# SMD-S ENCODING

AUTOMOTIVE NETWORK COMMUNICATION PROTOCOL

RENESAS ELECTRONICS CORPORATION

# IEEE 802.3br SPECIFICATION CONCERN

# AMBIGUOUS SPECIFICATION

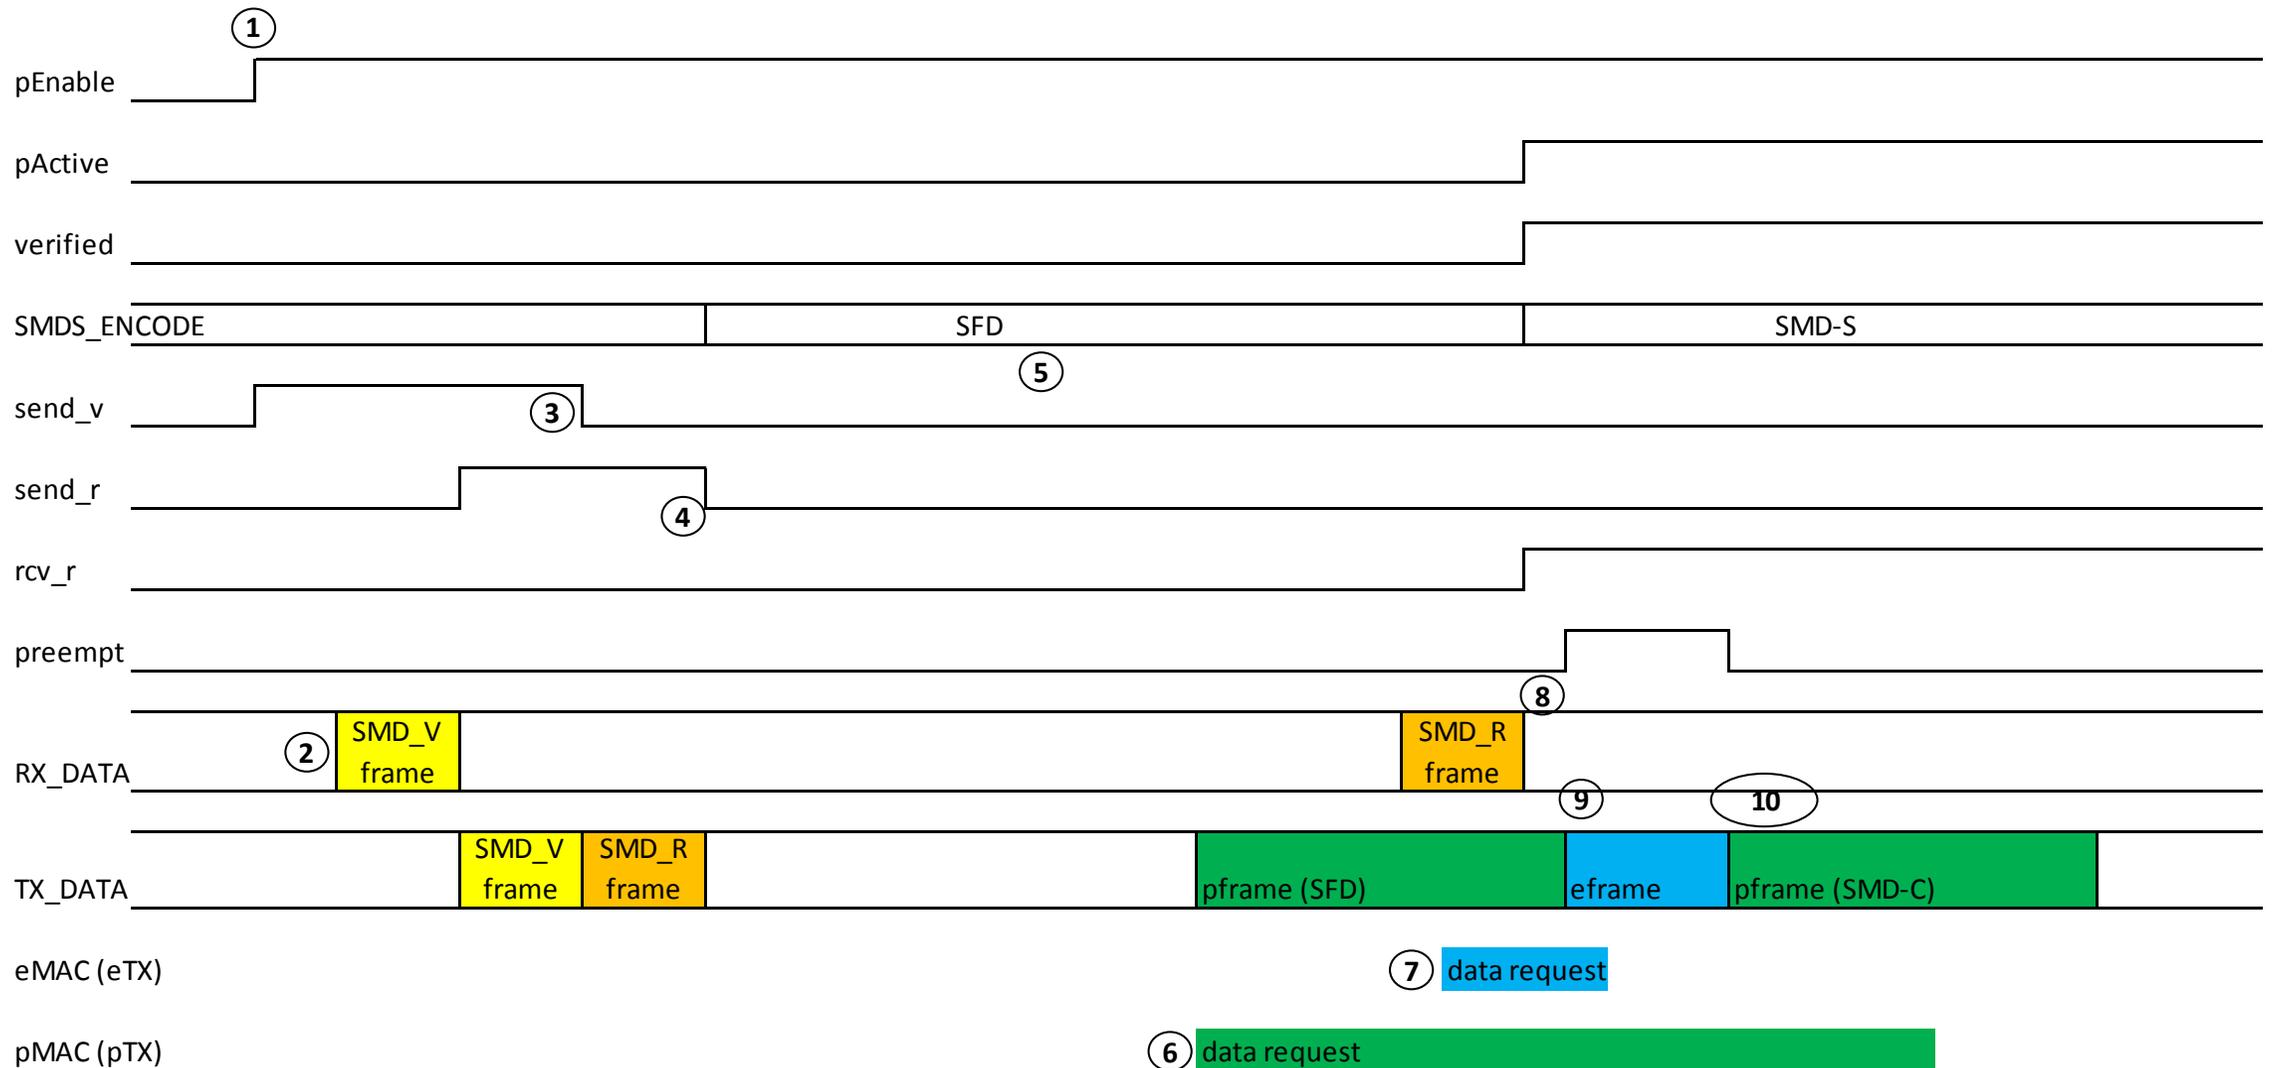
The definition of SMDS\_ENCODE permitted to set SMD-S to 0xD5 (i.e. SFD) when the parameter pActive is FALSE

pActive is TRUE when preemption capability is enabled and the link verification is completed

Therefore we see the possibility that the problem mentioned on the previous slide is possible when a preemptable frame is starting short before the pActive changed from FALSE to TRUE
